SUBJECT: AMENDMENT NO. 18 TO FACILITY OPERATING LICENSE NO. NPF-11-
LA SALLE COUNTY STATION, UNIT 1

AMENDMENT NO. 18 TO FACILITY OPERATING LICENSE NO. NPF-11-
LA SALLE COUNTY STATION, UNIT 1

Replace the following pages of the Appendix "A" Technical Specification with the enclosed pages. The revised pages are identified by Amendment number and contain verticle lines indicating the area change.

SECONDARY CONTAINMENT

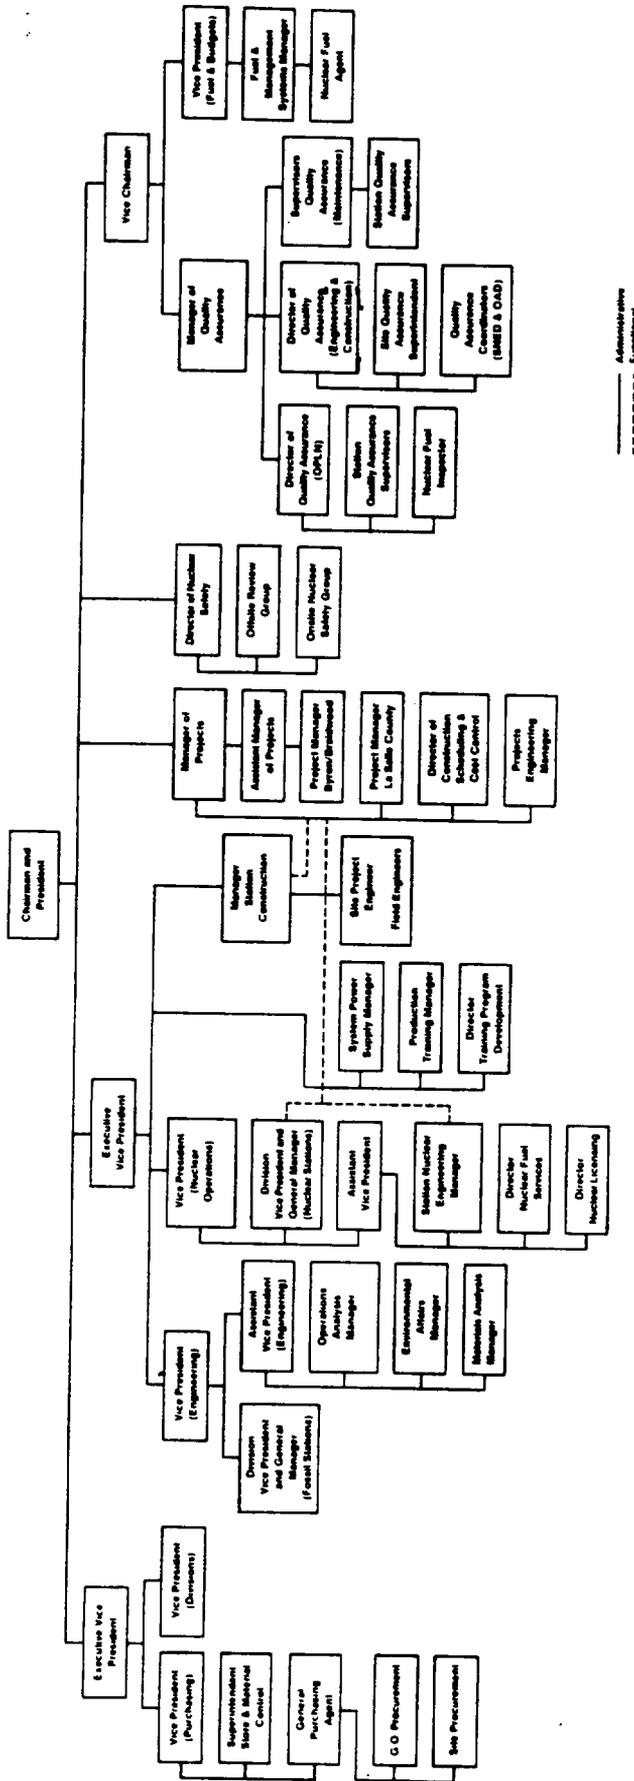
49. Page 5-1 - correct drywell free volume in design features portion of the Tech. Spec.
50. Page 6-11 - revise corporate management Figure 6.1-1 to reflect current approved management configuration.

5.2.3 The secondary containment consists of the Reactor Building, the equipment access structure and a portion of the main steam tunnel and has a minimum free volume of 2,875,000 cubic feet.
